In response to your telephone request of January 26, 1977, we are sending under separate cover 40 additional copies of the Watts Bar Nuclear Plant Environmental Information (November 18, 1976). This document updates the assessment provided by the Watts Bar Nuclear Plant Final Environmental Statement of November 1972.

WATTS BAR NUCLEAR PLANT UNITS 1 AND 2

ENVIRONMENTAL INFORMATION

This section identifies and discusses environmental aspects of those features relating to the design, construction, and operation of the Watts Bar Nuclear Plant which have been revised since the FES was published on November 9, 1972. There are nine general items discussed in this section. These are: (1) Watts Bar/Volunteer 500kV Transmission Line, (2) Location of blowdown diffusers, (3) Tritium disposal method, (4) water chemistry changes, (5) minor changes in construction practices, (6) visitor facilities, (7) addition of condensate demineralizers, (8) addition of radwaste evaporator and (9) other changes, miscellaneous items.

CONDENSER WATER SUPPLY
 WATTS BAR NUCLEAR PLANT
 COOLING TOWER BLOWDOWN
 DIFFUSER FACILITY-FIGURE 1

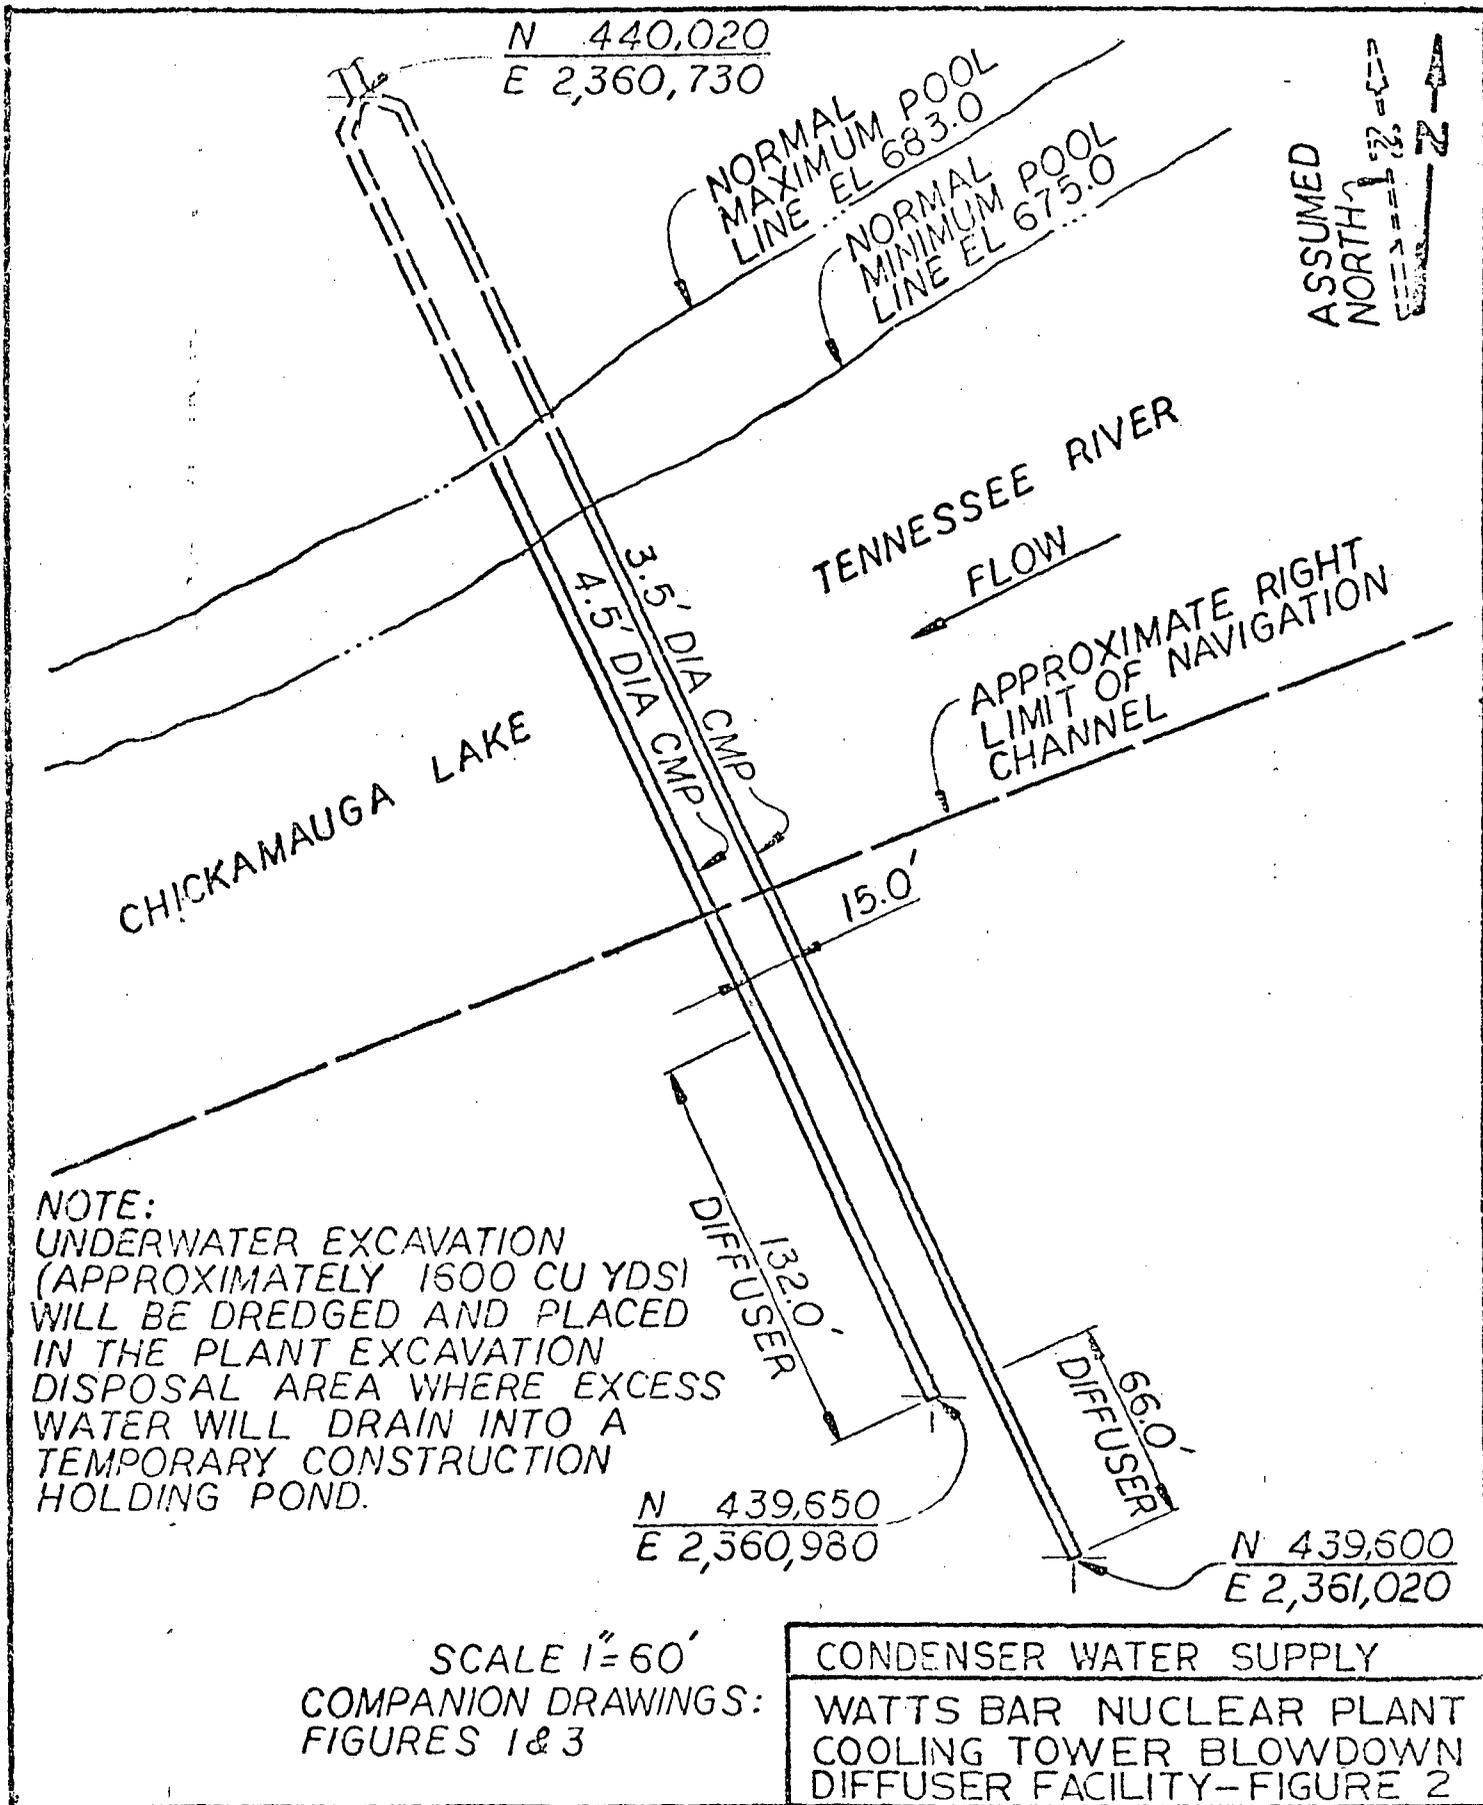
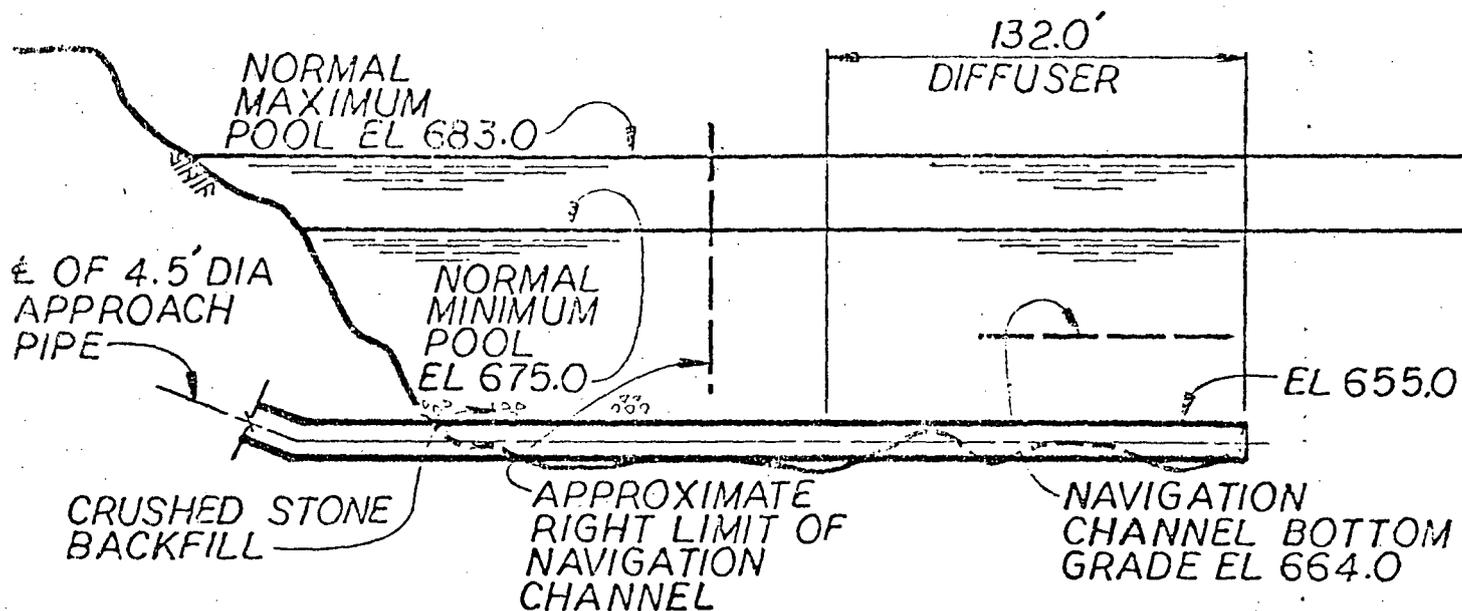
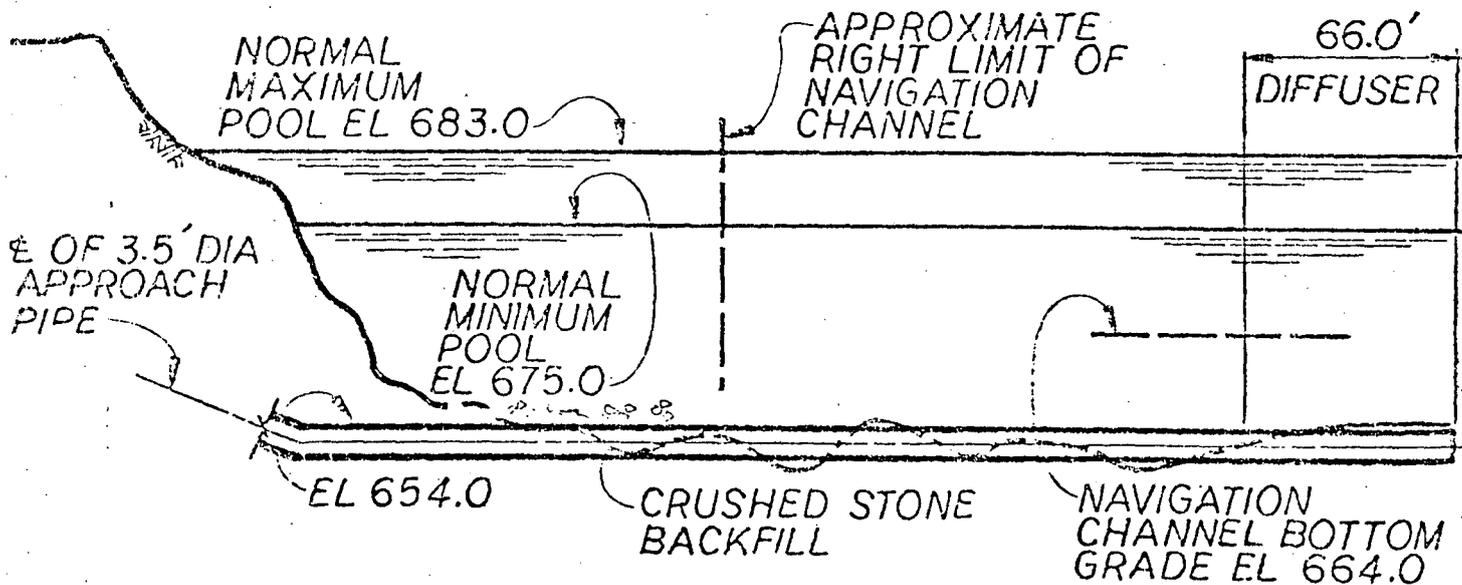
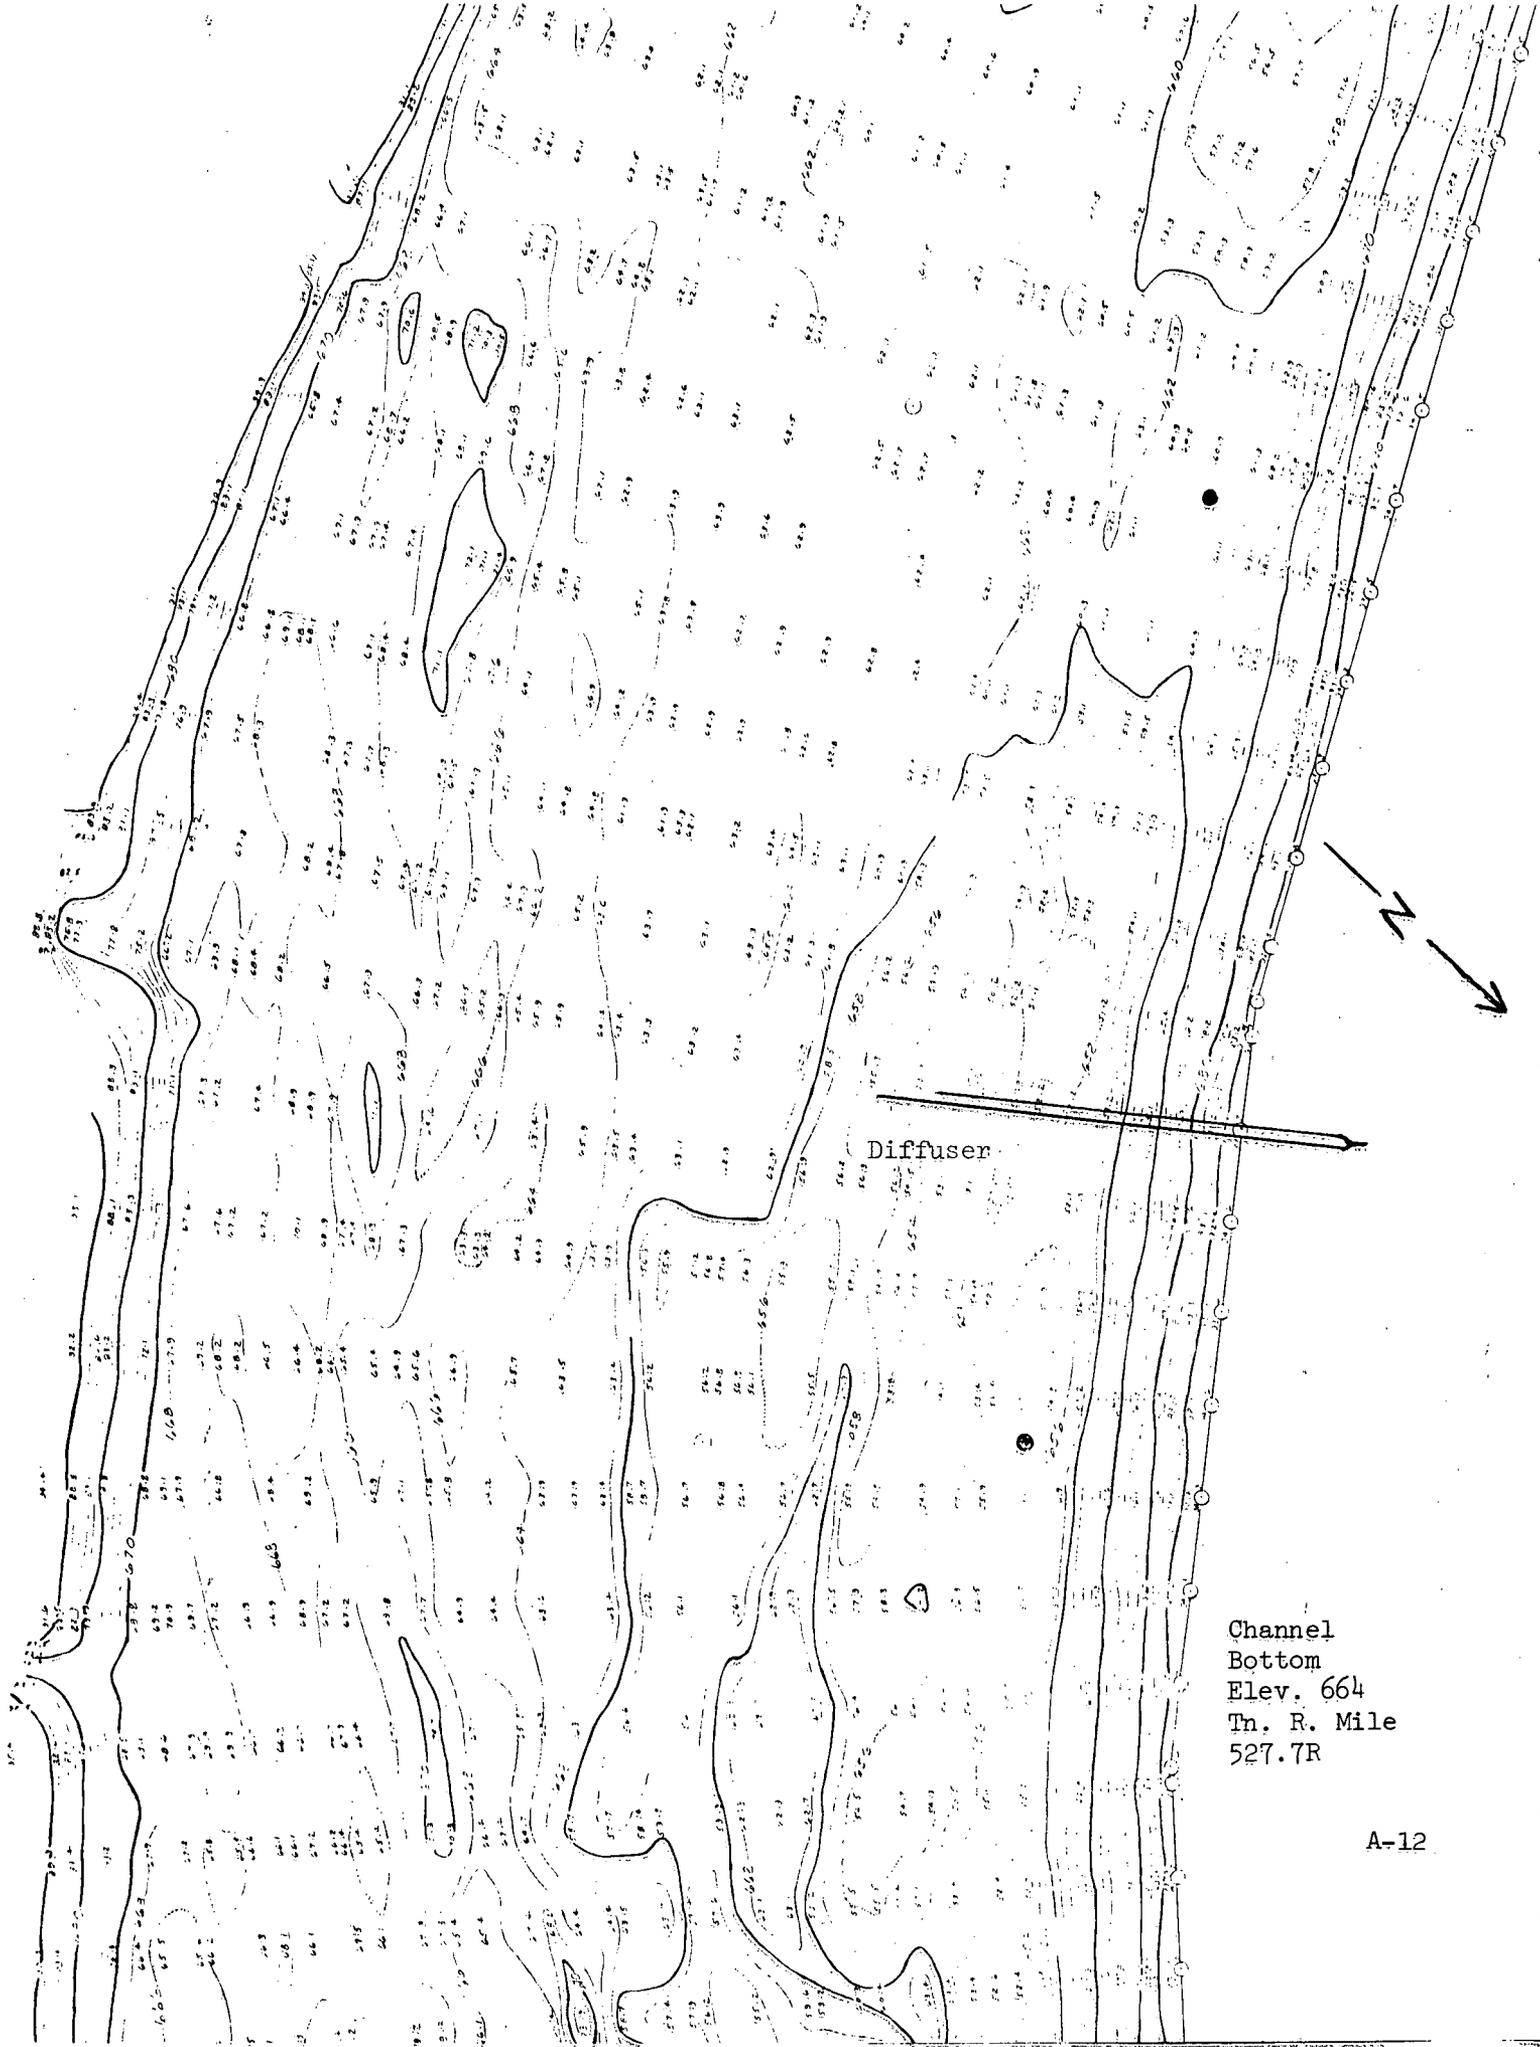
The TVA Watts Bar Nuclear Plant FES stated that blowdown from the cooling towers would be discharged by means of blowdown diffusers located in the Chickamauga Reservoir. The environmental assessment of this action was based on placement of the blowdown diffuser at about Tennessee River Mile (TRM) 527.6. This location has been determined to be infeasible due to insufficient river depths in that area. As a result, TVA has found it necessary to relocate the blowdown diffusers to an area approximately 1,000 feet upstream of the originally proposed location. Both locations are within an area designated by the State of Tennessee as a mussel sanctuary.

In choosing the location discussed above, TVA has conducted an environmental review of this action. The environmental review considered three reasonable alternatives. These alternatives consisted of (1) relocation of the diffuser system to an area of adequate depth for barge clearance approximately 1,000 feet upstream from the originally proposed area, (2) locating the diffusers as planned and realigning a total of about one mile of the present navigation channel in the Tennessee River (upstream and downstream) approximately 250 feet toward the left bank, away from the diffuser location, and (3) redesign and relocation of the diffusers to an area between the right bank and the navigation channel with the diffusers oriented parallel to the river flow.

Alternative 1 would have essentially the same environmental impact as that outlined for the original diffuser location outlined in the Watts Bar Nuclear Plant FES. TVA estimates that about 1,600 yd³ of material would

have to be removed, resulting in 0.3 acre of river bottom being disturbed. Owing to the nature of the substrate, the impact of this action on the mussel sanctuary below Watts Bar Dam is expected to be negligible. Alternative 2 is expected to result in the greatest environmental impact of all three alternatives since dredging work would be performed in areas designated as a mussel sanctuary by the State of Tennessee, as well as requiring a 1-mile realignment of the present river navigation channel. Alternative 3 would result in greater potential for environmental impacts on aquatic and terrestrial biota than Alternative 1 due to the requirement of a longer diffuser pipe system and also the effluent plume being closer to the right bank. Construction impacts for alternatives 1 and 3 would be expected to be nearly the same. Although the capital cost estimates favor alternative 3, the fact that the diffuser is oriented perpendicular to the river flow and consequently would provide more rapid dilution of thermal, radioactive and nonradioactive discharges weighs heavily in favor of alternative 1. TVA has conducted a review of these alternatives and determined that alternative 1 is the preferred selection with respect to feasibility, environmental impacts, and associated capital costs. See Figures 1, 2, and 3 for a detailed layout of the blowdown diffuser system chosen under alternative 1. A fourth figure shows bottom contours of the Tennessee River in the vicinity of river mile 527.7R. The streambed between the original diffuser location and the location of alternative 1 is mostly bedrock. Implementation of alternative 1 should result in minimal environment impacts to the overall aquatic ecosystem, and afford the greatest protection to the State of Tennessee mussel sanctuary below Watts Bar Dam.

The State of Tennessee indicated that their concurrence with alternative 1 was contingent upon disposal of spoil onshore and not back into the Tennessee River. TVA plans to use dredging equipment to remove the estimated quantity of 1,600 cubic yards of spoil material to an onshore location that will be properly diked to avoid excessive runoff. By letter dated May 14, 1976, TVA responded to the State of Tennessee's request for additional information concerning mussel beds between the original diffuser site and Watts Bar Dam (included at end of this discussion). As stated in this letter, TVA does not consider any of the mussel species found in the area of the Tennessee River below Watts Bar Dam to be endangered or threatened. However, one mussel species (Lampsilis orbiculata) found in the mussel bed from Tennessee River miles 527.6 to 528.5 has recently been determined by the U.S. Department of the Interior (Fish and Wildlife Service) to be an endangered species, pursuant to Section 4 of the Endangered Species Act of 1973 (see Federal Register, Vol. 41, No. 115-Monday, June 14, 1976, pages 24062-24067). This mussel bed is situated on the left side of the river navigation channel while the proposed discharge diffuser location at about TRM 527.7 is on the opposite side of the channel, along with the Watts Bar Nuclear Plant.

NOTE:
UNDERWATER EXCAVATION
(APPROXIMATELY 1500 CU YDS)
WILL BE DREDGED AND PLACED
IN THE PLANT EXCAVATION
DISPOSAL AREA WHERE EXCESS
WATER WILL DRAIN INTO A
TEMPORARY CONSTRUCTION
HOLDING POND.

Figure 2.4-1a
Steam Generator
Blowdown Treatment

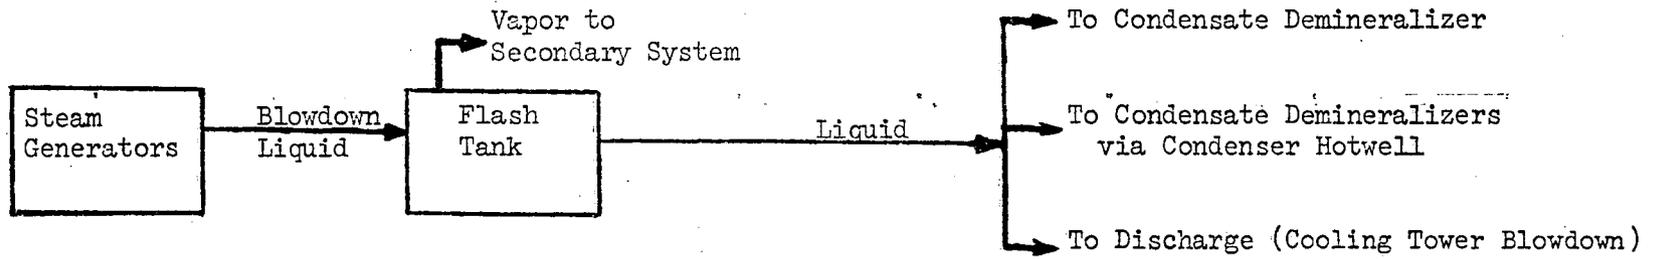
TVA has recently determined that with all-volatile treatment of the steam generators, condensate demineralizers should be added to protect the system against intrusion of impurities due to condenser leakage. As the condensate demineralizers would also have the capability for treating steam generator blowdown, the reverse osmosis-evaporator system discussed above would no longer be needed. It is expected that the condensate demineralizers will operate normally in a partial bypass mode, with approximately one-third of the flow from the condenser hotwell being passed through the demineralizers. The demineralizers will be switched to full flow operation upon detection of condenser leakage or primary-to-secondary leakage. This practice would ensure that radioactive materials released in steam generator blowdown to the reservoir are minimized and should result in lower quantities of radioactive materials in liquid effluents, thus providing a consequent reduction in radiological doses to downstream reservoir users.

Figure 2.4-1a (included at the end of this discussion) shows the routing of steam generator blowdown. The blowdown first enters a flash tank, where it is cooled as about one-half of the liquid entering the tank is converted to vapor. The vapor is recovered by sending it to a heater in the secondary system. The liquid is normally routed to the inlet header of the condensate demineralizers, so that liquid is processed whether the demineralizer is in bypass or full-flow operation. The liquid may also be routed to the condenser hotwell, from which it is pumped to the condensate demineralizers. This route is employed only when the demineralizers are in full-flow operation. The liquid may also be sent to discharge via the cooling tower blowdown line. This route will normally be used only during startups. Flow to discharge will be terminated manually when radioactivity is detected, and a radiation monitor will terminate the discharge automatically at a radioactivity concentration of 1×10^{-4} uCi/gm if it has not been terminated earlier by operator action. Upon termination of discharge, the blowdown flow is diverted, to the condensate demineralizers.
